Old Orchard Public Consultation

The Parish Council of Stretton on Dunsmore would like to register its opposition to the granting of planning application R20/0285.

Photo courtesy of Google Streetview

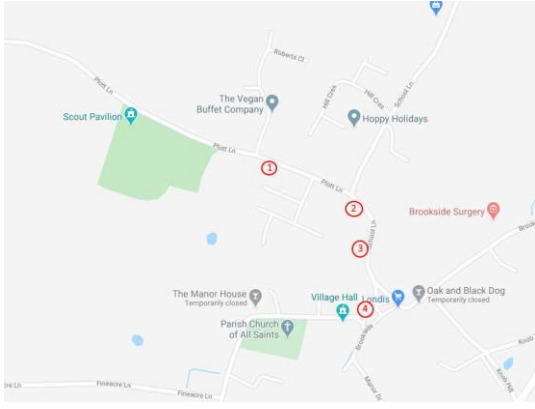
The application form (at question 8) asks “Do the proposals require any diversions/extinguishments and/or creation of rights of way?” to which the applicant answers in the negative. This may be true for public footpaths and bridleways but is not entirely correct. The Parish Council has the benefit of an enduring pedestrian and vehicular access across part of the site (the old park entrance) for use by the public. If the proposal went ahead this would conflict with the garden and building of plot 9.
